Project
KINGDOM CHRISTIAN SCHOOL

ALFRETON HALL
Church Street
Alfreton Derbyshire

Scale 1:100@A1
Date May 2026
Drwg 19A

EAST+NORTH ELEVATION

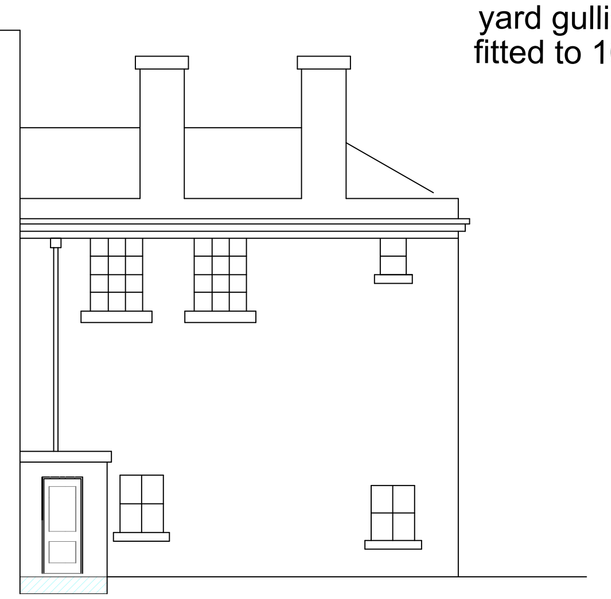
NOTE: Amended to remove wall-wash lighting

REVISION A 29 July 2026
Green Palisade fence moved to a position behind the Yew Hedge
